STATE OF NORTH CAROLINA
DEPARTMENT OF TRANSPORTATION

MEMORANDUM

SUBJECT: Preliminary pedestrian crossing recommendations for U-2801A - US 25A
(Sweeten Creek Road) from north of US 25 (Hendersonville Road) to Rock Hill
Road in Asheville, Buncombe County

Sweeten Creek Road at Pensacola Avenue

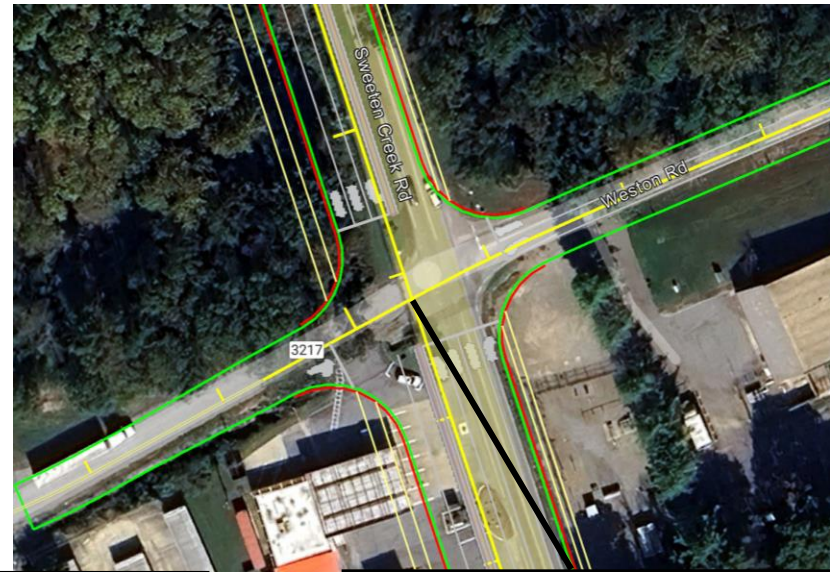
- Given that expanding the bridge just south of the project limits to carry a sidewalk is not an option, the project team should consider ending the sidewalk at Pensacola until future ped/bike facilities connect to US 25. It would be a good idea to acquire the necessary right-of-way now.

- Current: 3-leg, signalized, full access
- Proposed: 3-leg, signalized, full access
- For consistency in treating signalized intersections, crosswalks, ramps, and pedestrian signals are needed on all intersection legs.

Sweeten Creek Road at Cedar Lane

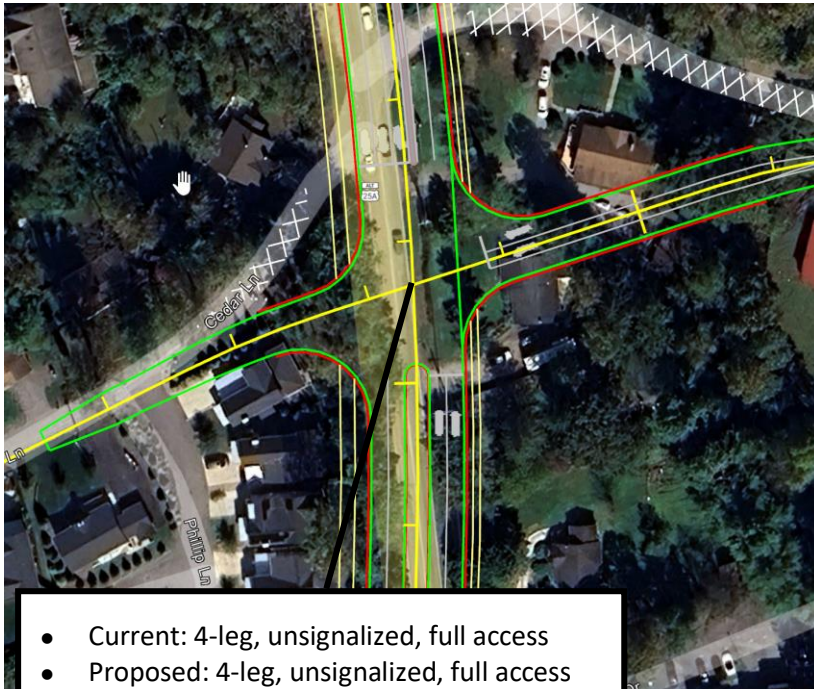
- Current: 4-leg, unsignalized, full access
- Proposed: 4-leg, unsignalized, full access
- Recommend a pedestrian hybrid beacon crossing Sweeten Creek Rd.

Sweeten Creek Road at Sycamore Drive

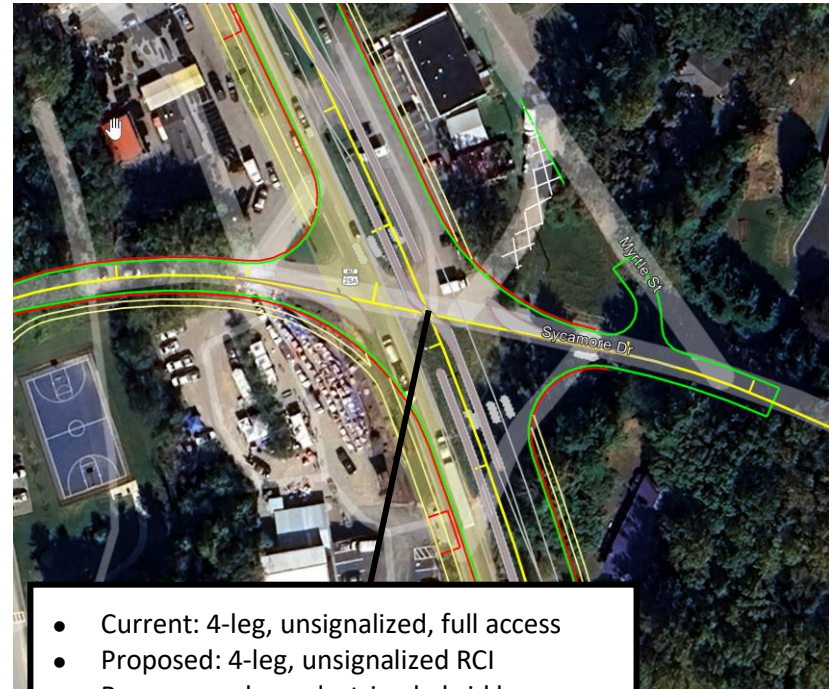
- Current: 4-leg, unsignalized, full access
- Proposed: 4-leg, unsignalized RCI
- Recommend a pedestrian hybrid beacon crossing Sweeten Creek Rd, wider median to accommodate a Z-type crossing.

Sweeten Creek Road at Royal Pines Drive

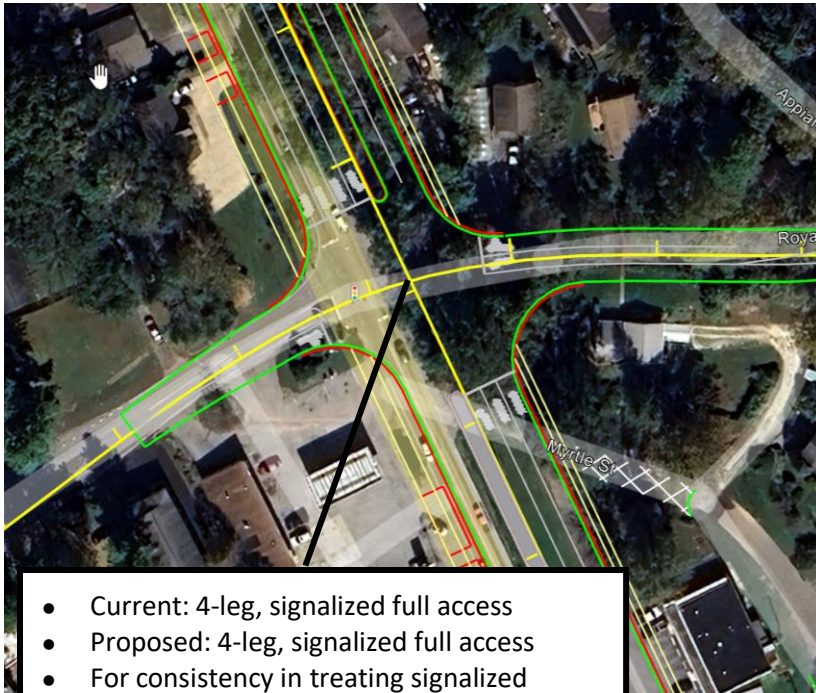
- Current: 4-leg, signalized full access
- Proposed: 4-leg, signalized full access
- For consistency in treating signalized intersections, crosswalks, ramps, and pedestrian signals are needed on all intersection legs.

- Current: 4-leg, unsignalized, full access
- Proposed: 4-leg, unsignalized RCI
- Recommend a pedestrian hybrid beacon crossing Sweeten Creek Rd with a Z-type crossing.

Sweeten Creek Road at Rosscraggon Road

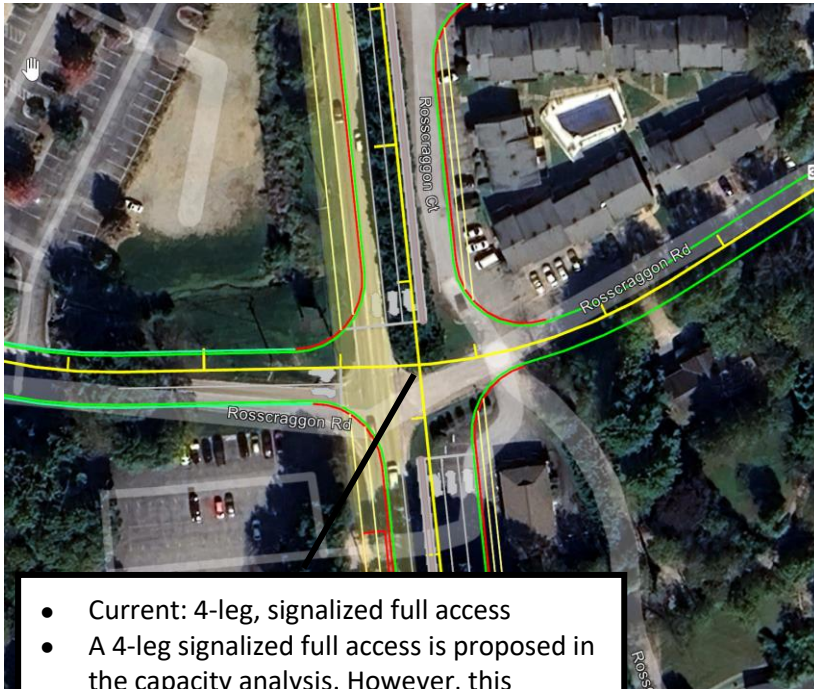
- Current: 4-leg, signalized full access
- A 4-leg signalized full access is proposed in the capacity analysis. However, this intersection currently restricts eastbound left turns. Any eastbound left turning traffic can utilize the Sweeten Creek Rd at Rathfarham Rd signalized intersection. Consideration should be given to an unsignalized RCI at this intersection in lieu of a traffic signal.

Sweeten Creek Road at Rathfarnham Road

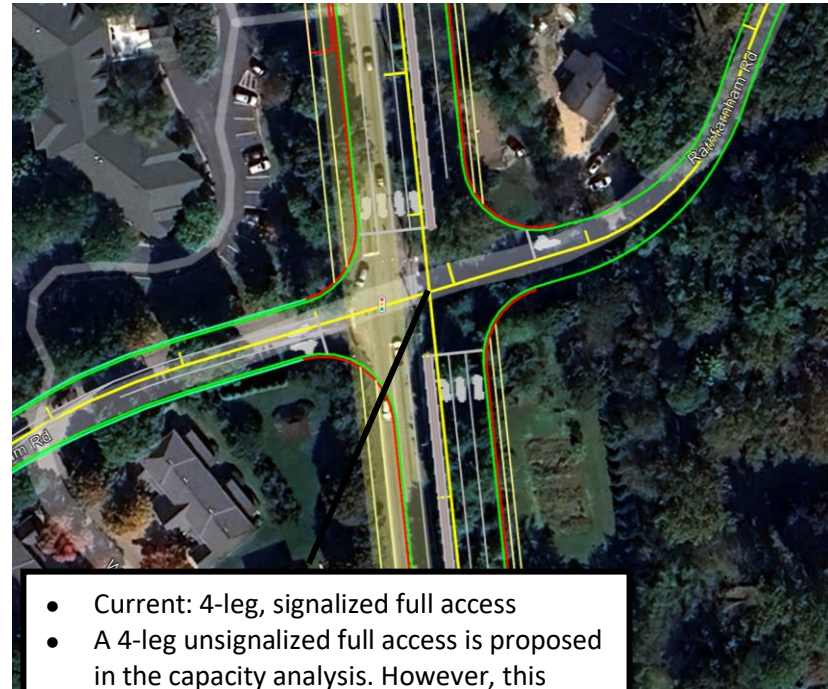
- Current: 4-leg, signalized full access
- A 4-leg unsignalized full access is proposed in the capacity analysis. However, this intersection is currently signalized and accommodates the eastbound left turns that are restricted at Rosscraggon Rd. The recommendation is to retain a traffic signal at this intersection.
- For consistency in treating signalized intersections, crosswalks, ramps, and pedestrian signals are needed on all intersection legs.

Sweeten Creek Road at Kensington Place

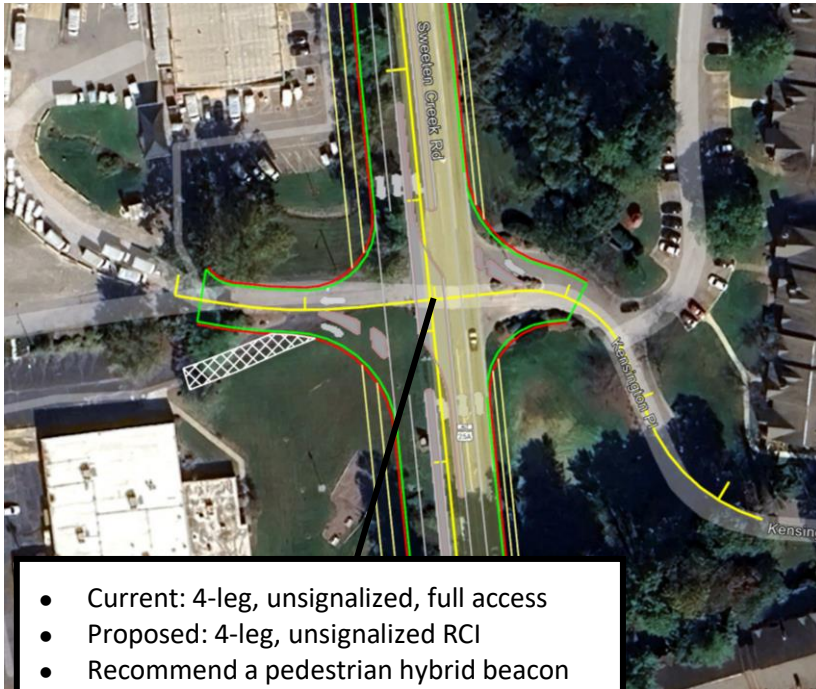
- Current: 4-leg, unsignalized, full access
- Proposed: 4-leg, unsignalized RCI
- Recommend a pedestrian hybrid beacon crossing Sweeten Creek Rd with a Z-type crossing.

Sweeten Creek Road at Mills Gap Road

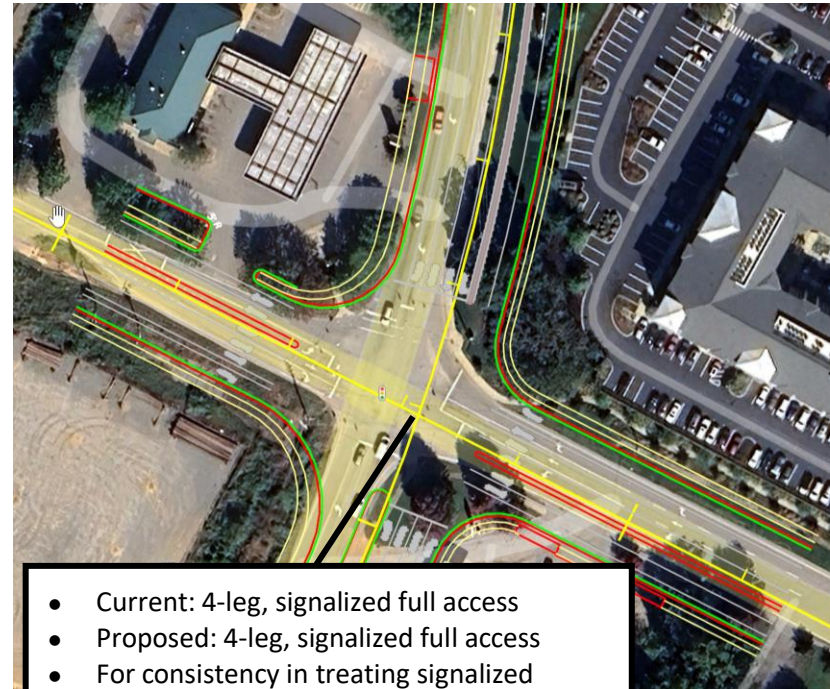
- Current: 4-leg, signalized full access
- Proposed: 4-leg, signalized full access
- For consistency in treating signalized intersections, crosswalks, ramps, and pedestrian signals are needed on all intersection legs.

Sweeten Creek Road at Gerber Road

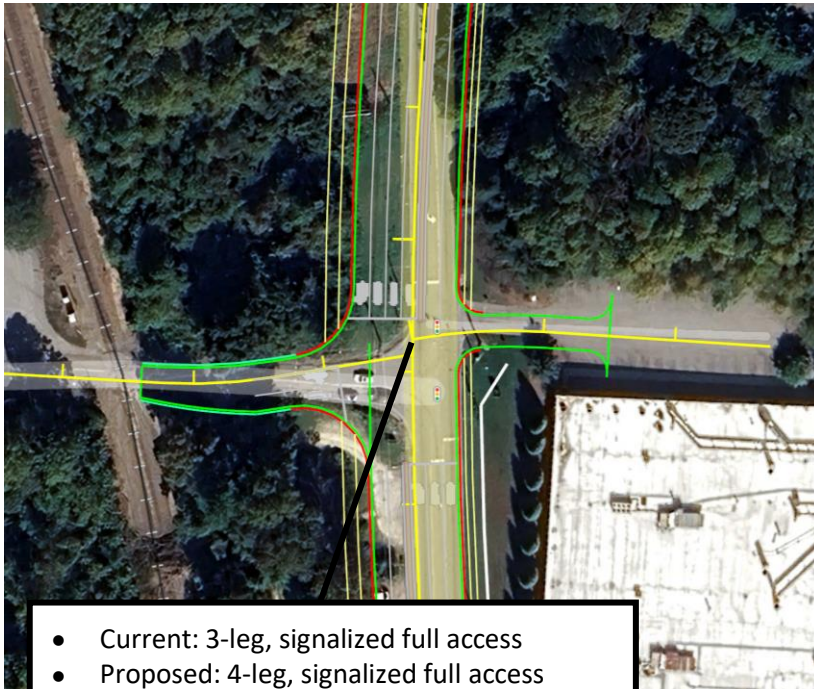
- Current: 3-leg, signalized full access
- Proposed: 4-leg, signalized full access
- For consistency in treating signalized intersections, crosswalks, ramps, and pedestrian signals are needed on all intersection legs.

Sweeten Creek Road at Wesley Drive

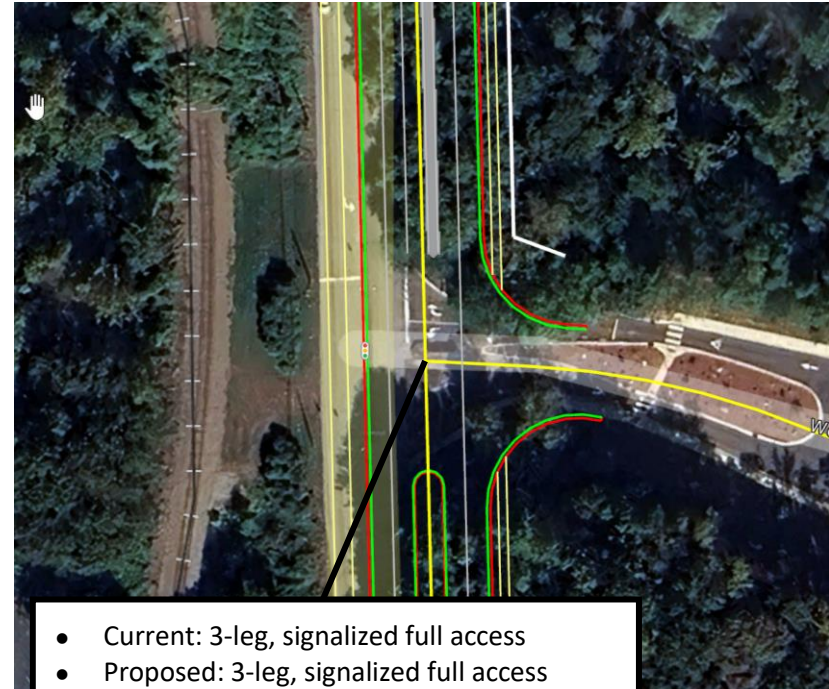
- Current: 3-leg, signalized full access
- Proposed: 3-leg, signalized full access
- For consistency in treating signalized intersections, crosswalks, ramps, and pedestrian signals are needed on all intersection legs.

Sweeten Creek Road at Woodland Meadows Drive

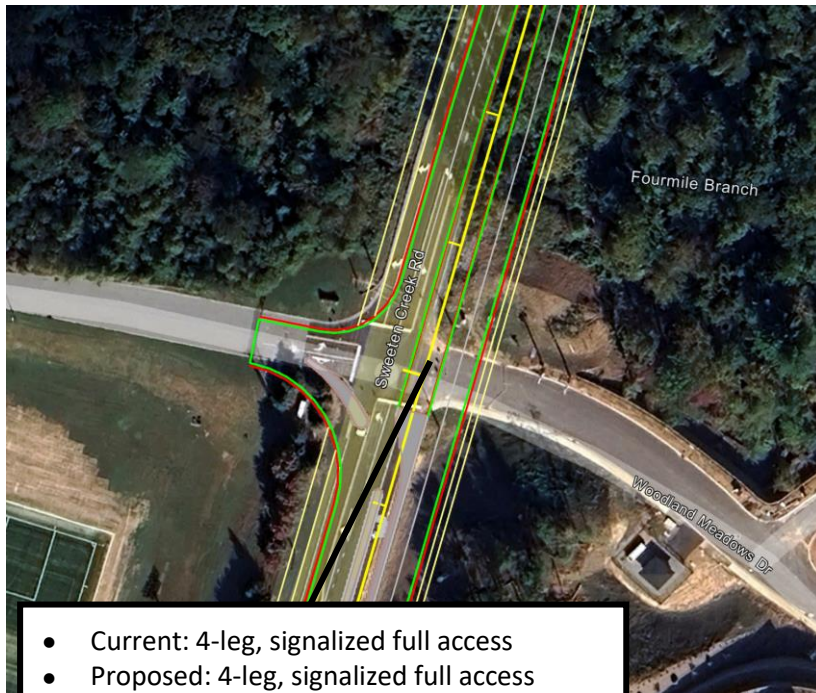
- Current: 4-leg, signalized full access
- Proposed: 4-leg, signalized full access
- For consistency in treating signalized intersections, crosswalks, ramps, and pedestrian signals are needed on all intersection legs.

Sweeten Creek Road at Rock Hill Road

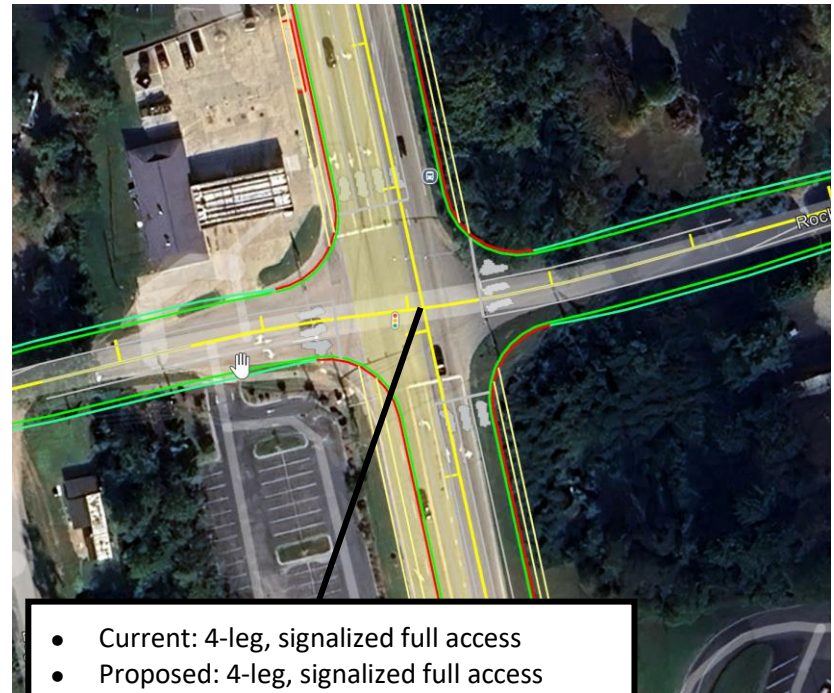
- Current: 4-leg, signalized full access
- Proposed: 4-leg, signalized full access
- For consistency in treating signalized intersections, crosswalks, ramps, and pedestrian signals are needed on all intersection legs.
